UNITED STATES PATENT AND TRADEMARK OFFICE

APPLICATION NO.	FILING DATE	FIRST NAMED INVENTOR	ATTORNEY DOCKET NO.	CONFIRMATION NO.
10/070,776	04/08/2002	Etienne Cousin	BDL-379XX	9662

Office Action Summary

DETAILED ACTION

Fig. 11.

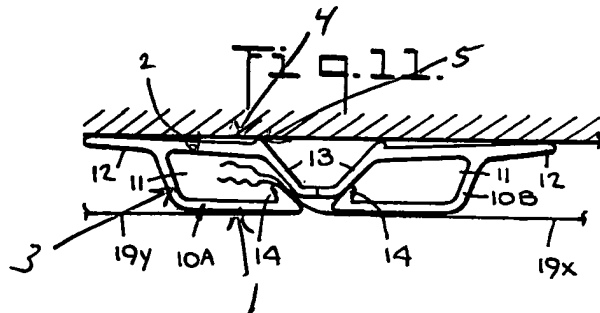
In regard to claim 1, Baslow discloses a rail section for stretched fabric partitions, said section comprising a groove 11 defined by an internal wing 1 (examiner's attachment), an external wing 2, and a base 3, an interval 4, i.e. the space between the rail and the wall, adjacent to the external wing and separating the external wing from a mounting surface, a joint including a lip 13, and a flap 5 outside the groove, said flap extending outward from said external wing toward said mounting surface, said lip being shaped and configured to pinch the fabric of the false partition between said lip and said internal wing, figure 11.
